# MtIntosh

C 26

### SERVICE INFORMATION

# SERVICE BULLETIN

LEFT CHANNEL PREAMP PRINTED CIRCUIT BOARD 043-991

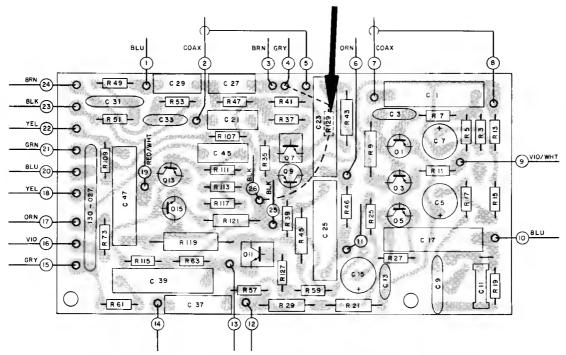
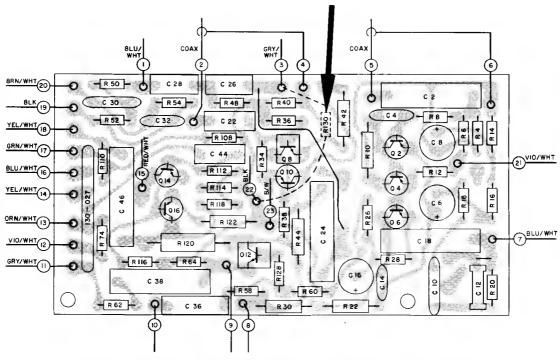
#### LOW FREQUENCY FILTER SWITCH MODIFICATION

PURPOSE OF MODIFICATION: To eliminate a "popping" sound when the low frequency filter switch is depressed.

WHAT UNITS ARE AFFECTED: Serial No. 10P01 to 30P52 Only.

Step 2 Add 1 resistor to the bottom side of each PC board as shown. The parts appear as R129 and R130 on the drawing.
